SB Number:	SB 2C9-021	Creation Date: 20/04/2005
Subject:	Reinforcing fixation of fulcrum pin for strap left cover	
Model:	KM-1620 / 2020

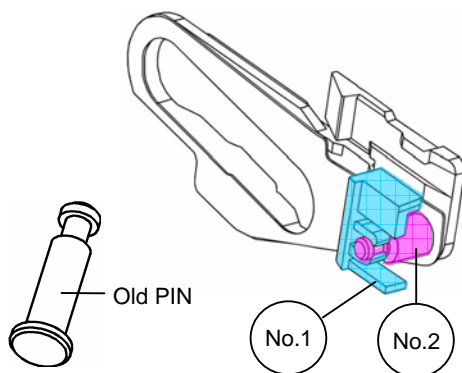
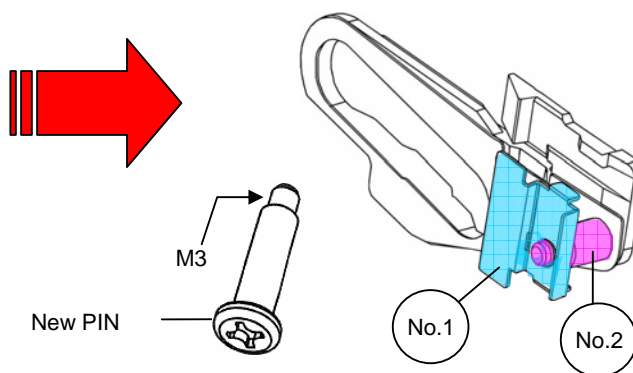
Presently the fulcrum pin (No.2) is fitted into the 'PLATE FRONT STRAP' (No.1 old parts) which is made of resin. To reinforce the fixation of the fulcrum pin, the fulcrum pin (No.2) is changed to screw type. By changing the type of fulcrum pin, the screw type of new fulcrum pin (No.2) is secured on the 'PLATE FRONT STRAP B' (No.1 new parts) which is made of metal.

Fulcrum pin (No.2) is fitted into 'PLATE FRONT STRAP' (No.1 old parts).

The screw type of the new fulcrum pin (No.2) is secured on 'PLATE FRONT STRAP B' (No.1 new parts).

When replacing old with new parts, please replace No. 1 through 2 at the same time
